PEACH BOTTOM ATOMIC POWER STATION, UNIT NO. 2

AMENDMENT TO FACILITY OPERATING LICENSE

Amendment No. 153  
License No. DPR-44

ATTACHMENT TO LICENSE AMENDMENT NO. 153

Figure 3.6.1 Peach Bottom 2 Minimum Temperature for Pressure Tests Such as Required by Section XI

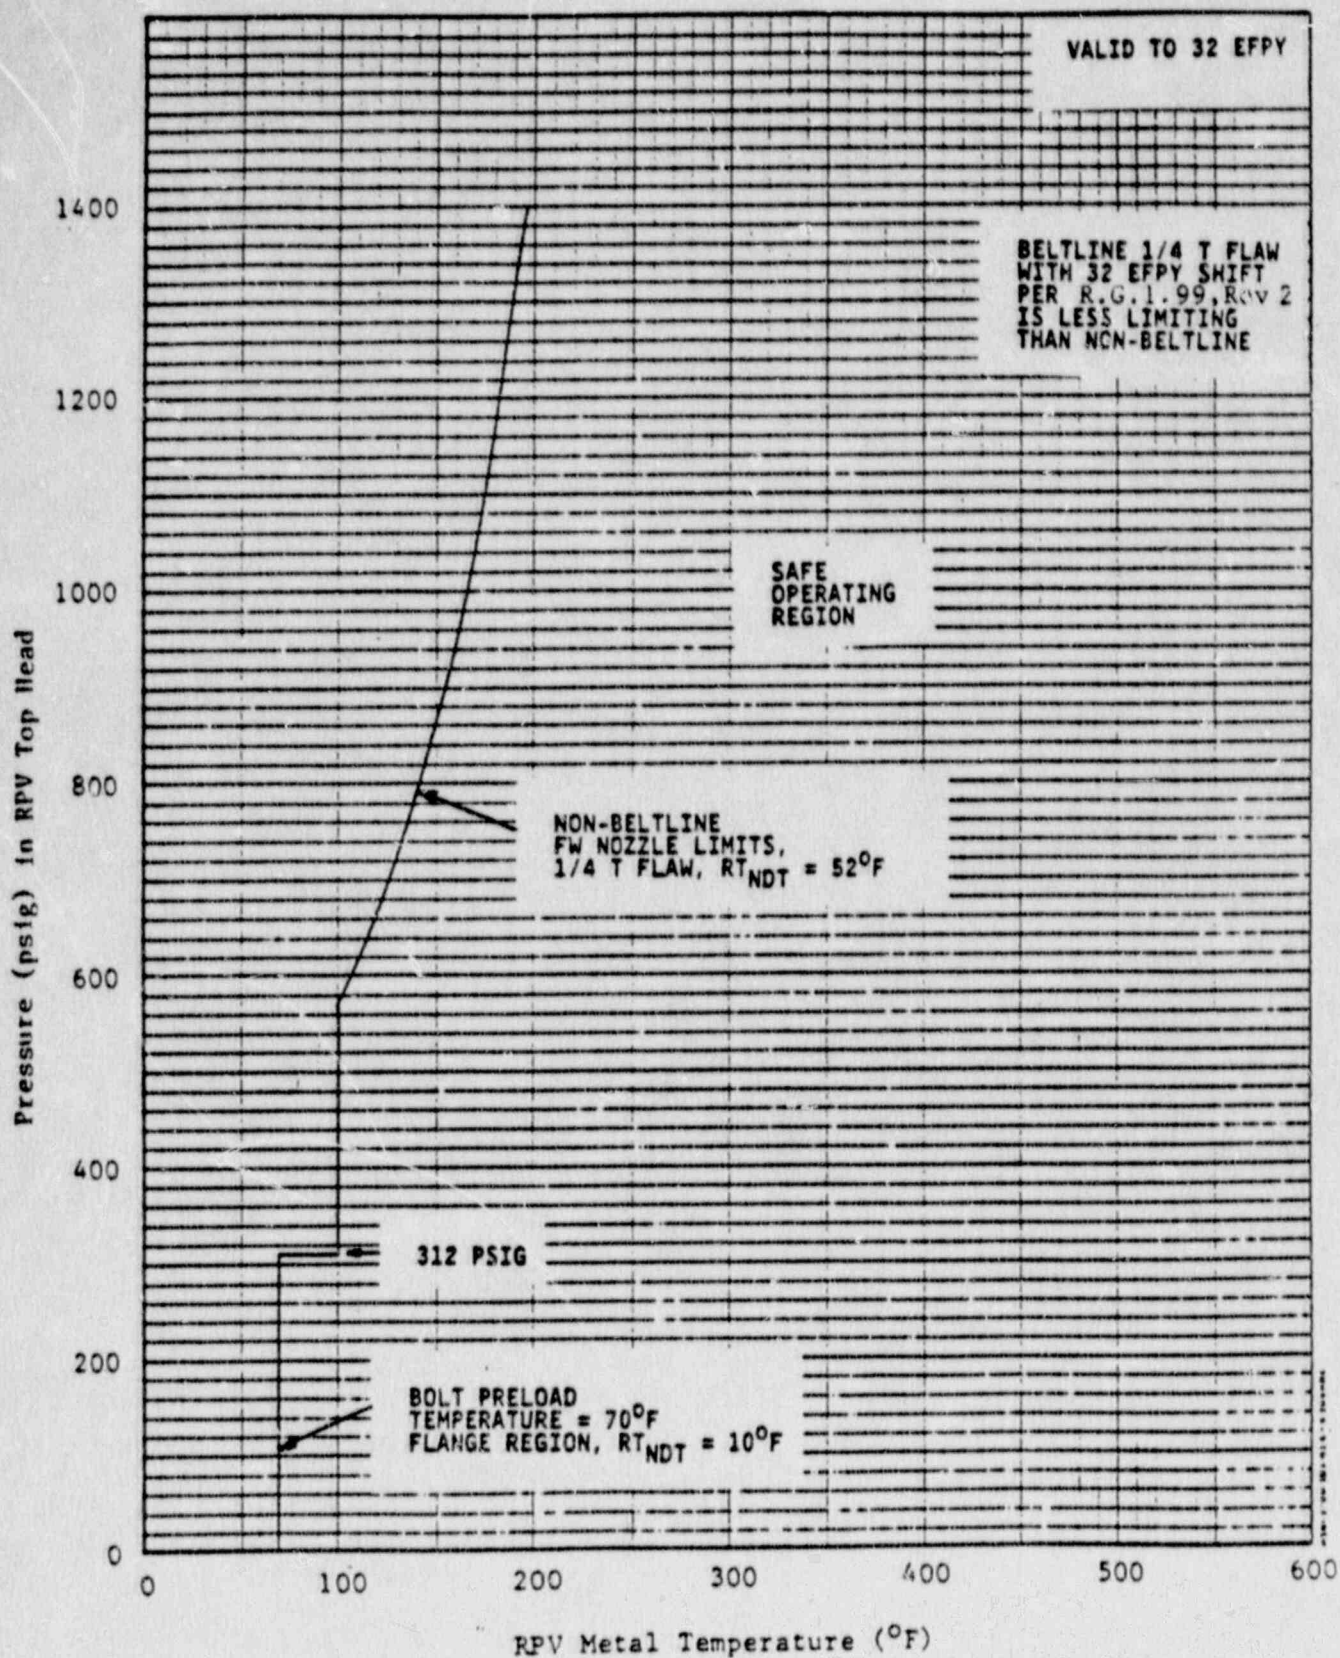
1. The average rate of reactor coolant temperature change during normal heatup or cool-down shall not exceed 100° F increase (or decrease) in any one-hour period.
2. The reactor vessel shall not be pressurized for inservice hydrostatic testing above the pressure allowable for a given temperature by Figure 3.6.1.

Selected surveillance specimens shall be removed\* and tested to experimentally verify or adjust the calculated values of integrated neutron flux and irradiation embrittlement that are used to determine the RT<sup>NDT</sup> for Figures 3.6.1, 3.6.2 and 3.6.3, and the figures shall be updated based on the results.

The flux wire test results provide the flux at one location in the vessel. The flux distribution can be determined analytically from the core physics data. The ratio of the flux at the peak vessel location to that at the flux wire location, known as the lead factor, was calculated to relate the flux wire test results to the maximum value for the vessel. In developing Figures 3.6.1, 3.6.2 and 3.6.3, the shift predicted by Regulatory Guide 1.99, Revision 2 methods for 32 EFPY of fluence was taken into account. However, in comparing the beltline operating limits (with 32 EFPY shift) to the feedwater nozzle limits, it was determined that the feedwater nozzle was more limiting. Since the feedwater nozzles do not experience significant changes in fracture toughness due to irradiation, the pressure-temperature limits in Figures 3.6.1, 3.6.2 and 3.6.3 apply, without any  $RT_{NDT}$  shifting, through 32 EFPY of operation.

Figure 3.6.2 Peach Bottom 2 Minimum Temperature for Mechanical Heatup or Cooldown Following Nuclear Shutdown

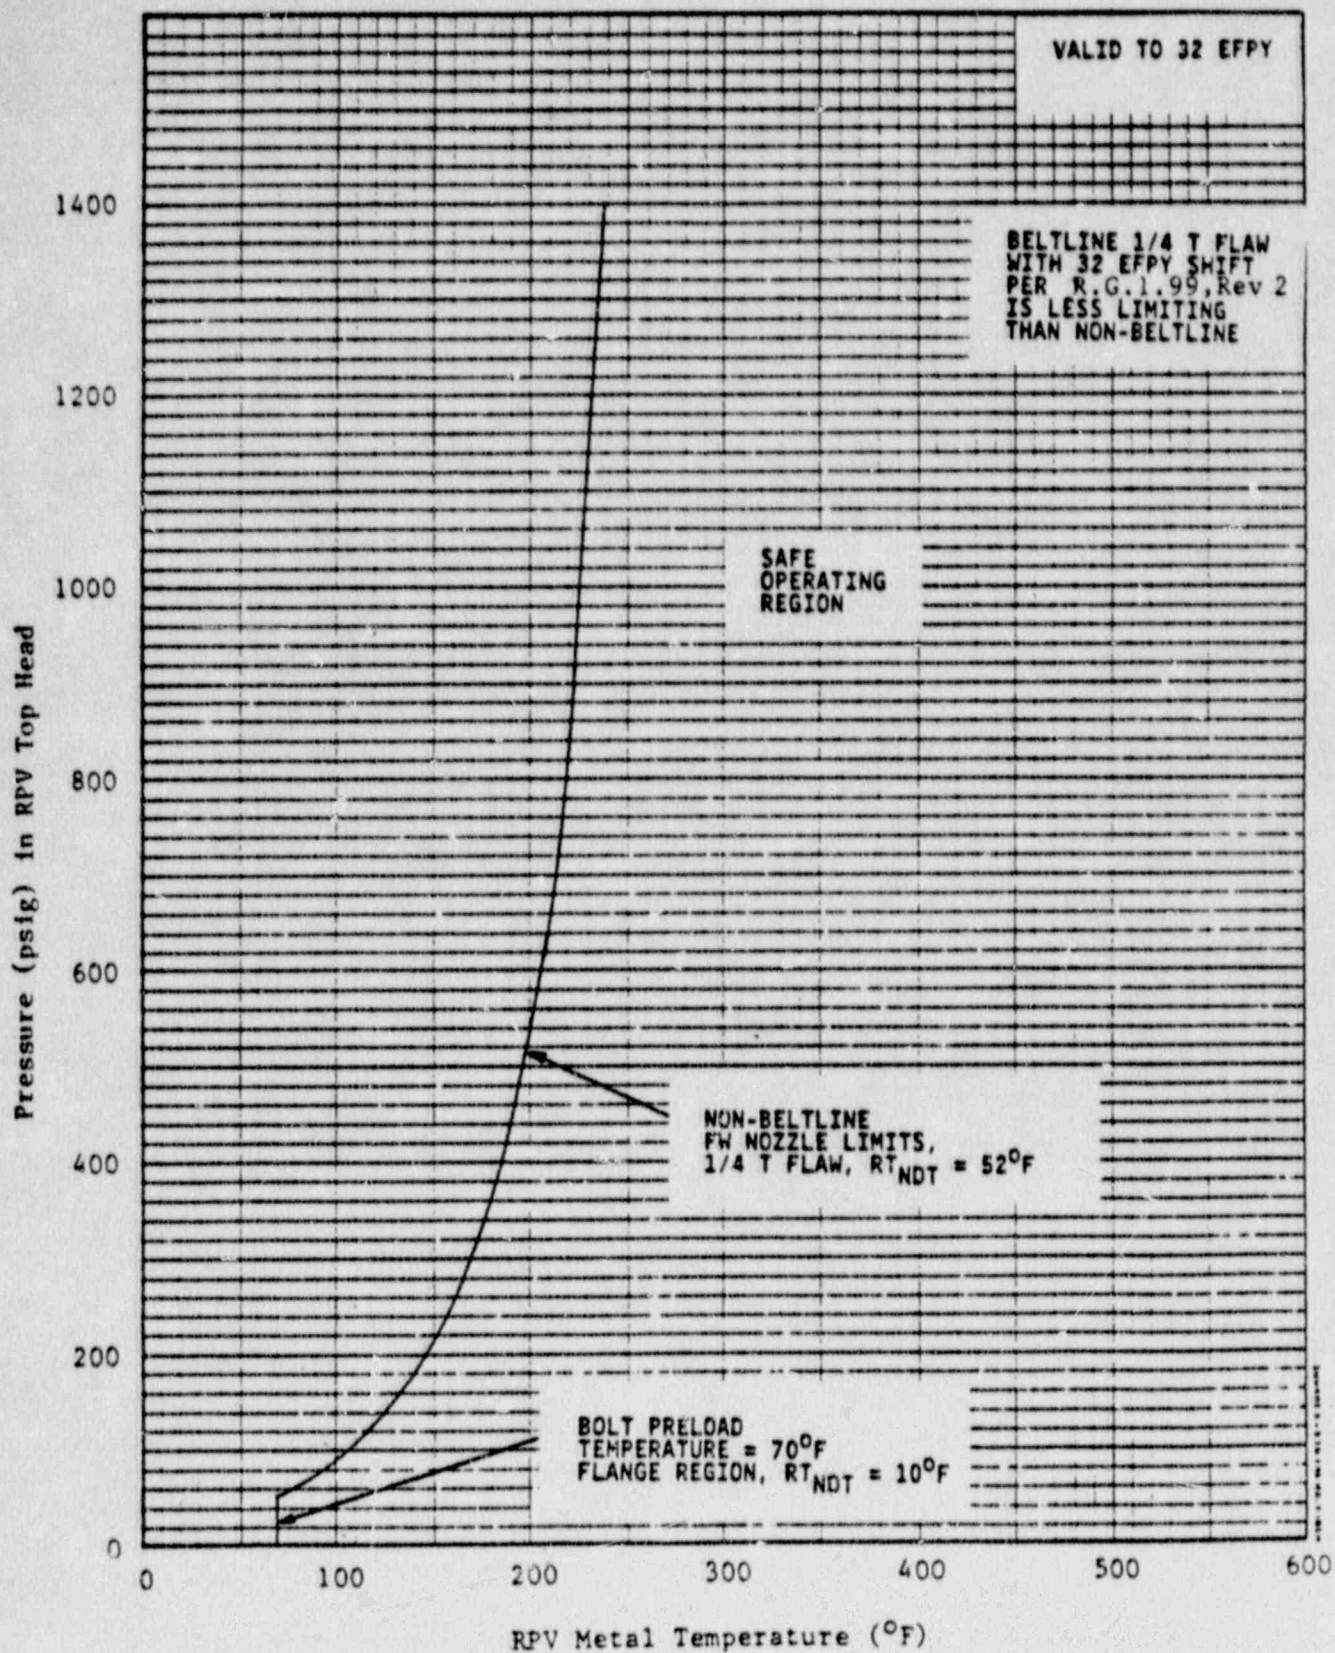
The reactor vessel shall not be pressurized during heatup by non-nuclear means, during cooldown following nuclear shut down or during low level physics tests above the pressure allowable by Figure 3.6.2, based on the temperatures recorded under 4.6.A.

Figure 3.6.3 Peach Bottom 2 Minimum Temperature for Core Operation (Criticality)

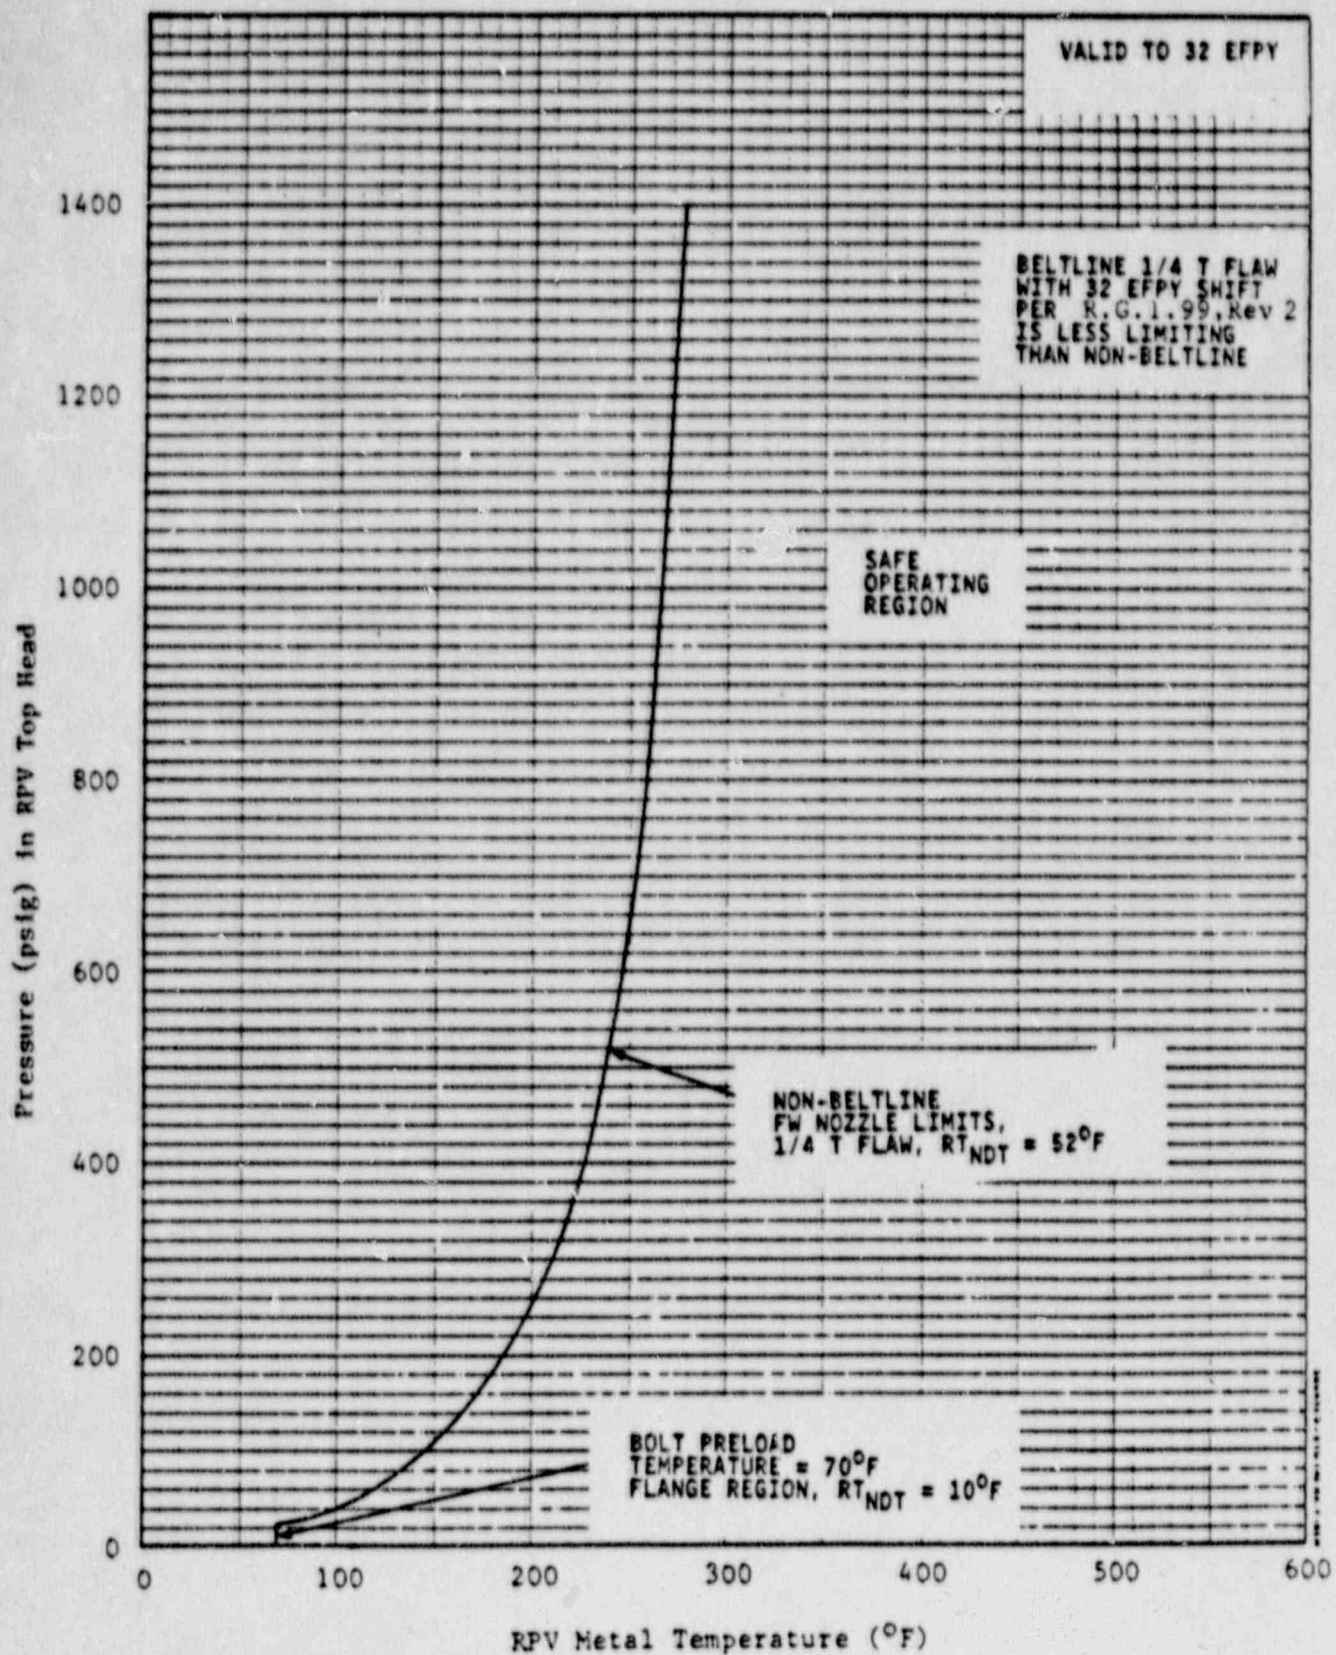
The reactor vessel shall not be pressurized during operation with a critical core above the pressure allowable by Figure 3.6.3, based on the temperatures recorded under 4.6.A.

Operating limits on the reactor pressure and temperature were developed after consideration of Section III of the ASME Boiler and Pressure Vessel Code and Appendix G to 10 CFR Part 50. These considerations involved the reactor vessel beltline and certain areas of discontinuity (e.g. feedwater nozzles and vessel head flange). These operating limits (Figures 3.6.1, 3.6.2 and 3.6.3) assure that a postulated surface flaw can be safely accommodated. Figure 3.6.3 includes an additional 40° F margin required by 10 CFR 50 Appendix G.
